****Technical Campaign****

Shift Assistant

**R 1200 GS (K50, 0A11),
 R 1200 GS Adventure (K51, 0A12),
 R 1200 RT (K52, 0A13),
 R 1200 RS (K54, 0A15)**

Service Information No. SI 23 001 17

Figure 1:

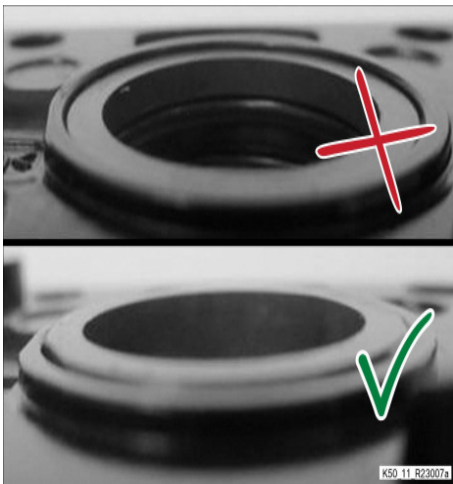
During the course of the quality analysis carried out by BMW Motorrad, it has been determined that for the R 1200 models with the gearshift assistant (SA X222A) OE, a few faulty gearshift assistants have been installed in the production period from 09/02/2016 to 09/05/2016. Over the service life of the vehicle, there can be impairment of functions up to a loss of function of the gearshift assistants.

- Top: Gearshift assistant with incorrectly installed bearing
- Bottom: Trouble-free gearshift assistant

As of 09/06/2016, vehicles are produced with trouble-free gearshift assistants.

Renew the gearshift assistant as described in labor operation 23 14 006.
